PRODUCT SAFETY

Snap-on Incorporated

SAFETY RETROFIT

Automotive Lift used for General Service and Vehicle Alignment
Open Front 4-Post Lifts - 172" and/or 210" Wheelbase capabilities, with 24" wide runways.

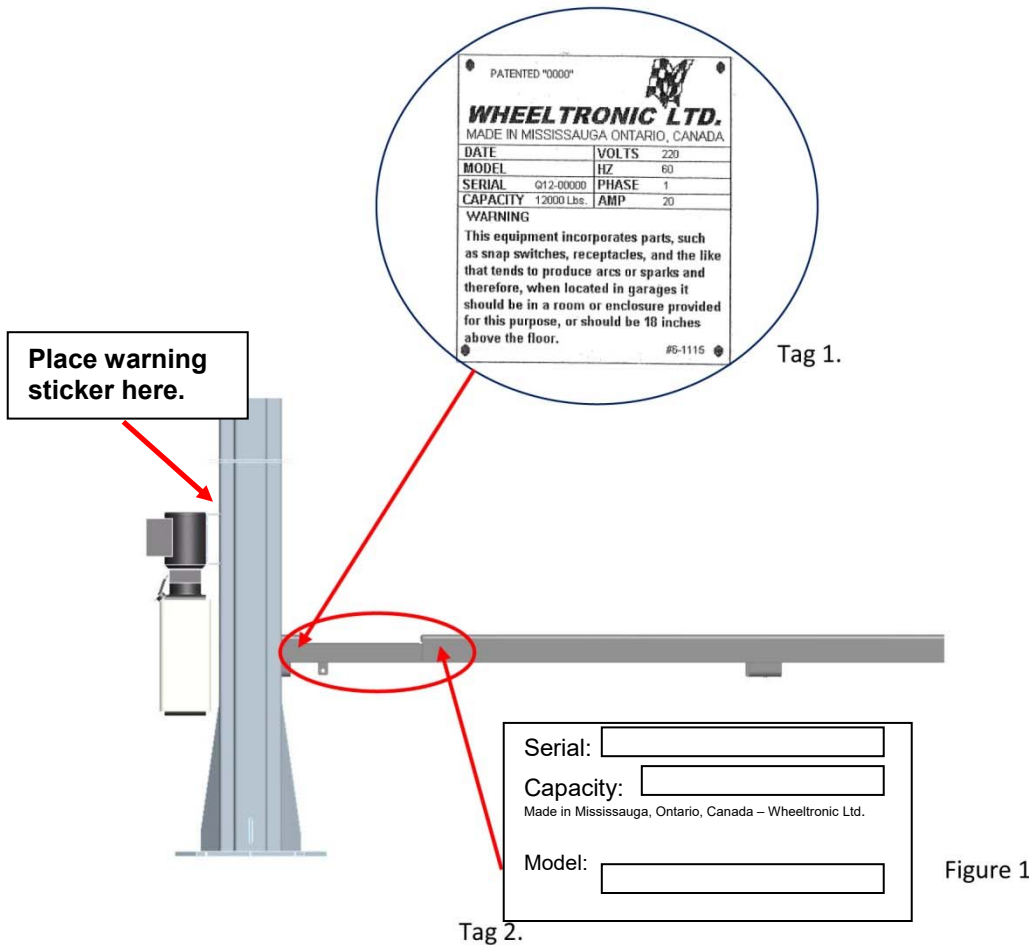
Please inspect the Model Number/Serial Number tag on the lift (See Fig. 1 on the next page).

Please affix the enclosed warning sticker to the lift column in the location identified in Figure 1.
